Project: Nebraska Heart Hospital - Hybrid Operating Room Addition **3850**

Date: April 9, 2012
To: All bidders of record
From: Dan Mulligan, AIA

This addendum is hereby made a part of the contract documents to the same extent as though it were originally included therein. Revisions and clarifications to the drawings are referenced by the drawing number.

addendum no. 1

sketch **M403a**

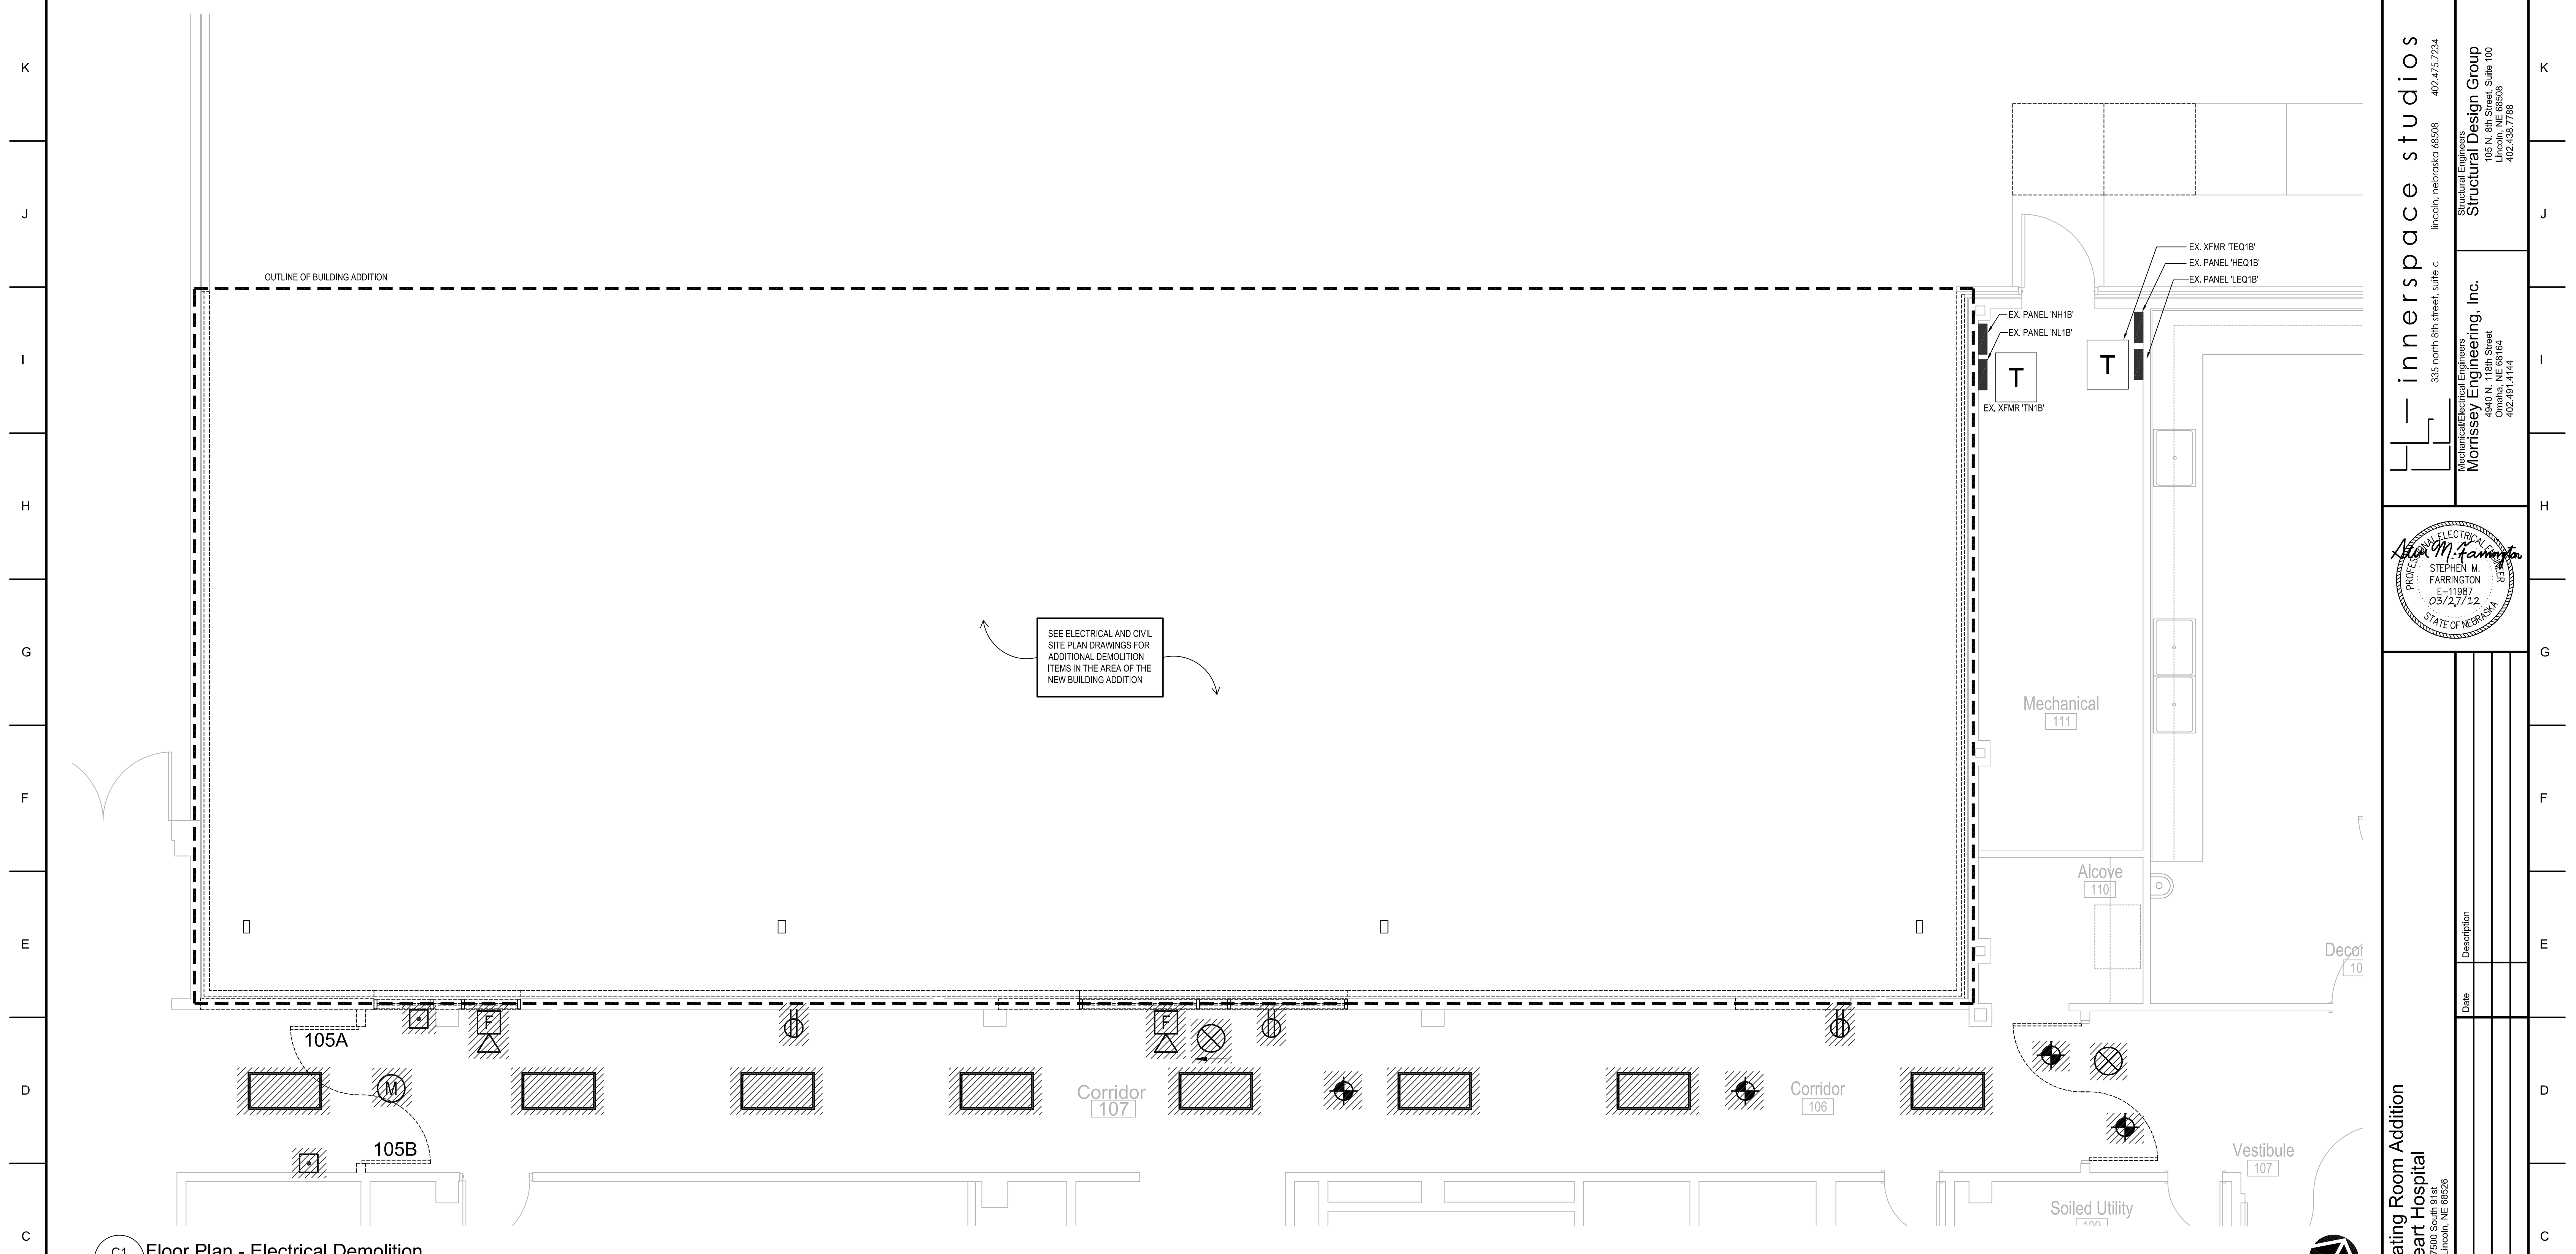
1. Revise heating coil schedule per Sketch Sheet M403a.

COIL SCHEDULE						
GENERAL	PLAN TAG	HC-1	HC-2	HC-3	CC-1	
	MANUFACTURER	TRANE	TRANE	TRANE	TRANE	
	MODEL NUMBER	DP4B12	DTTB18	D5WB30	UW	
	SERVES	CNTRL RM	TECH RM	OR #4	OR#4 AHU	
	APPROXIMATE SIZE (LxW)(IN)	12" x 12"	20" x 18"	24" x 30"	41.5x72	
	MIN. ROWS	2	1	2	6	
	MAX. FINS PER INCH	14	11	14	12	
	REMARKS	(1)	(1)	(1)	-	
AIR	AIRFLOW (CFM)	400	2,200	4,100	6,700	
	MAX. FACE VELOCITY	700	880	700	500	
	MAX. AIR PRESSURE DROP (IN. WG)	.15	0.26	0.29	0.744	
	ENTERING AIR TEMP (°F)	50	50	50	78/65	
	LEAVING AIR TEMP (°F)	93	80	81	52/51	
	TOTAL CAPACITY (MBH)	18.65	71.58	140.27	260	
	REMARKS	-	-	-	-	
HOT WATER	ENTERING WATER TEMPERATURE (°F)	180	180	180	-	
	LEAVING WATER TEMPERATURE (°F)	160	160	160	-	
	WATER FLOW (GPM)	1.5	7.15	13.5	-	
	MAX. WATER PRESSURE DROP (FEET)	10	10	10	-	
	REMARKS	-	-	-	-	
CHILLED WATER	ENTERING WATER TEMPERATURE (°F)	-	-	-	45	
	LEAVING WATER TEMPERATURE (°F)	-	-	-	55	
	WATER FLOW (GPM)	-	-	-	52	
	MAX. WATER PRESSURE DROP (FEET)	-	-	-	18

C1 Floor Plan - Electrical Demolition
E100 1/4" = 1'-0"

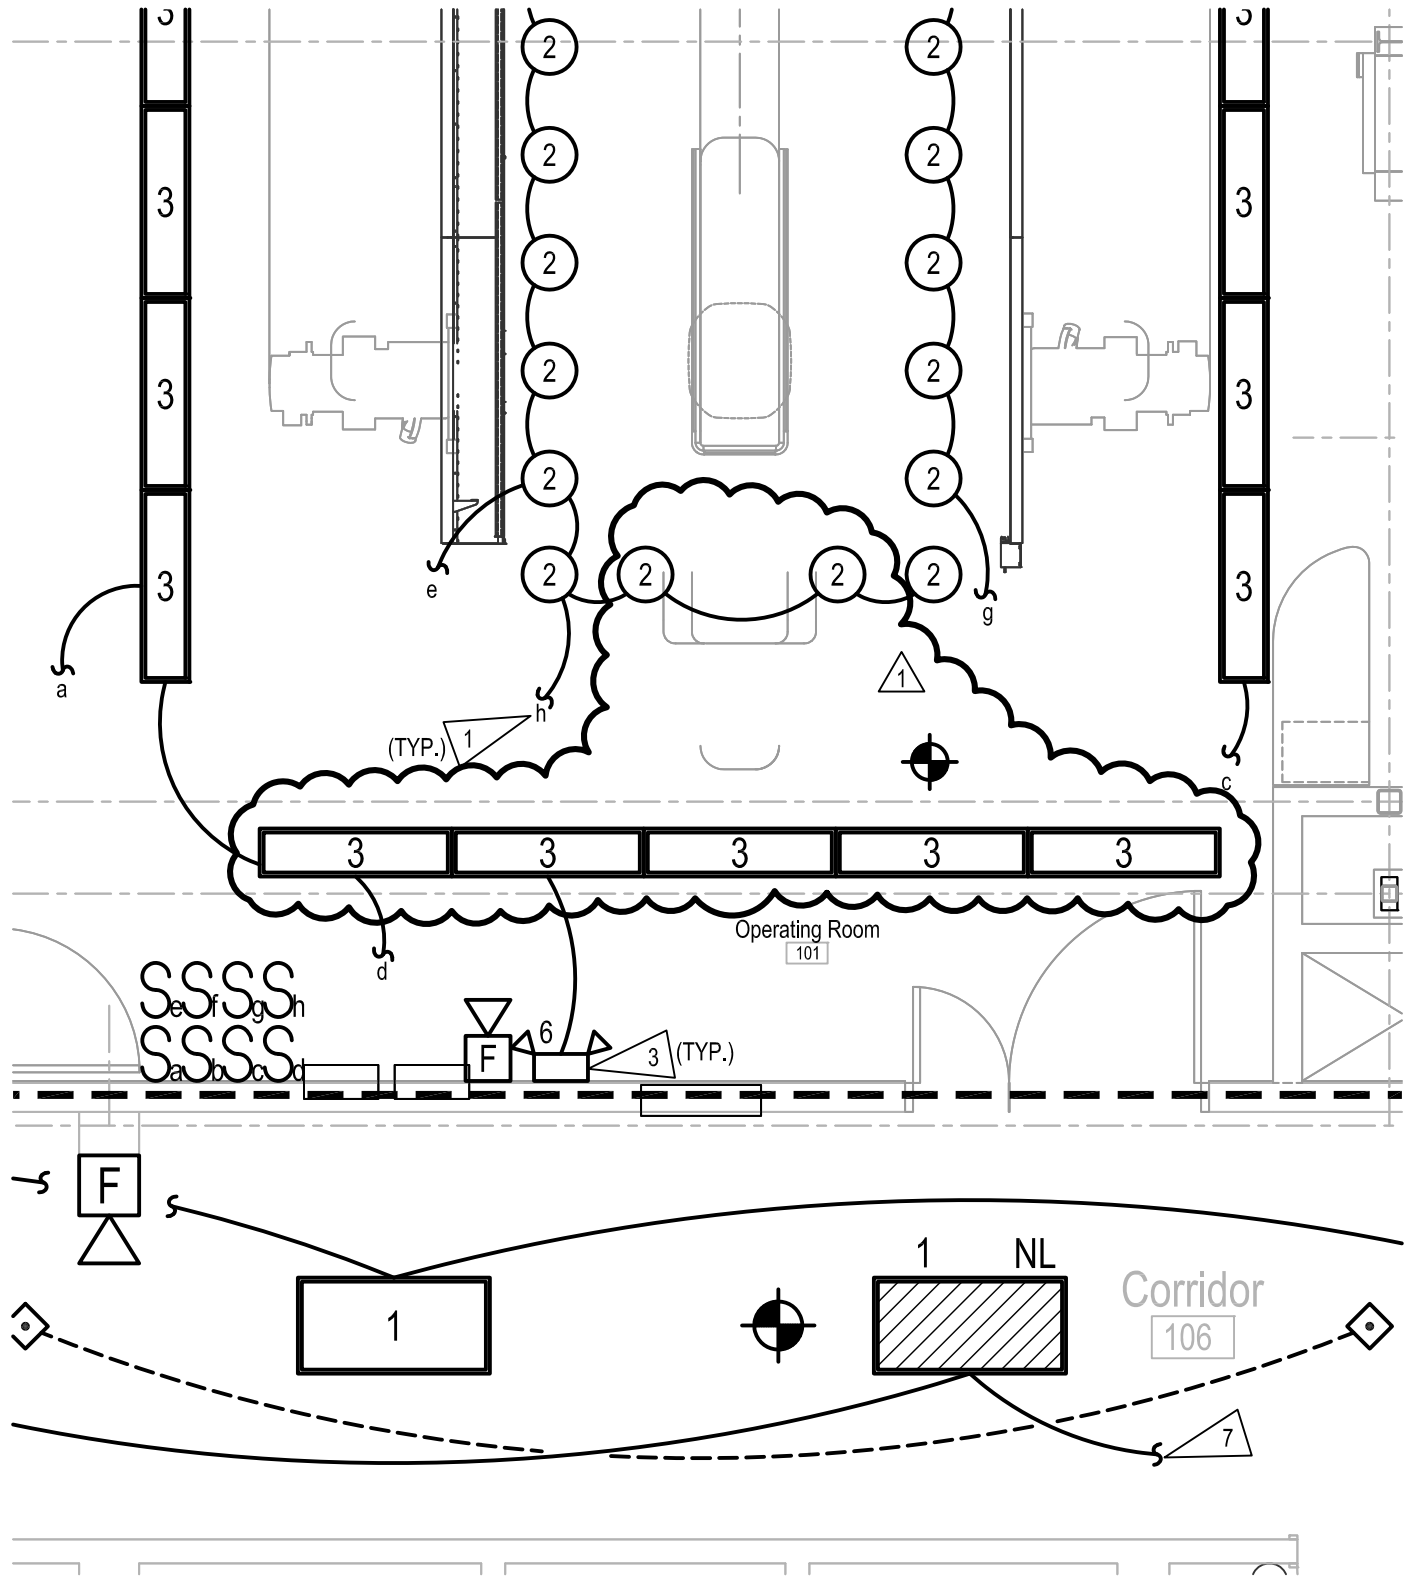
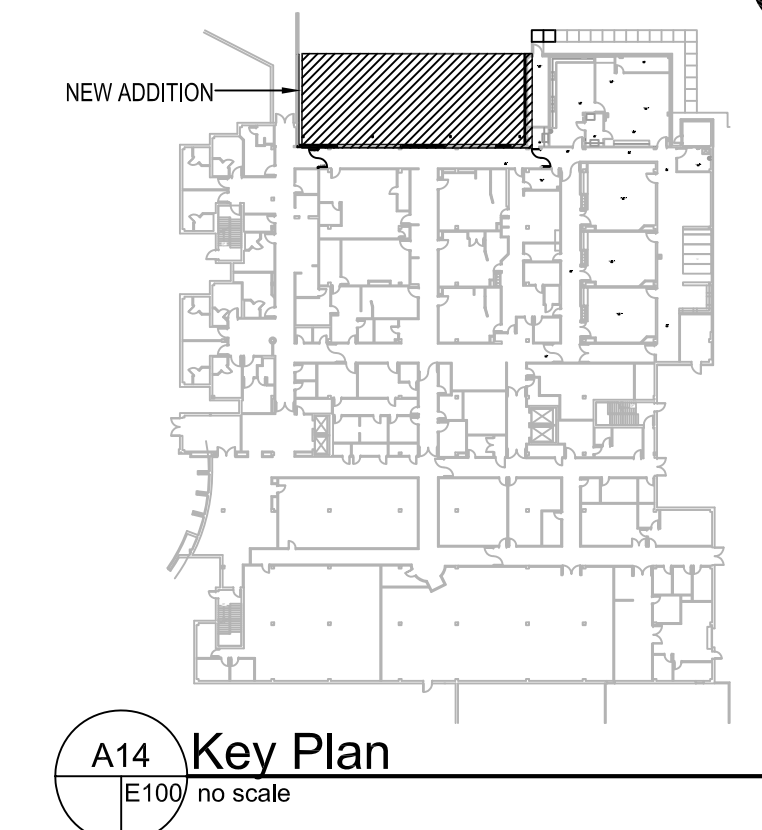
1. General Items:
 - a. Fire Alarm - The fire alarm is required to be installed by Continental Alarm.
 - b. Low Voltage Cabling - The low voltage cabling contractor is required to be Prime Communications or Lines of Communication.
2. Include Sheet E100: Floor Plan - Electrical Demolition.
3. Sheet E101 - Floor Plan - Lighting: Revise lighting per Sketch Sheet E101a.
4. Include Sheets E601 and E602: Philips Equipment - Power Plans. The drawings are supplementary information from the manufacturer. The electrical connections are to be installed per these documents.
5. Include Sheets E701 through E706: Maquet Equipment - Power Plans. The drawings are supplementary information from the manufacturer. The electrical connections are to be installed per these documents.
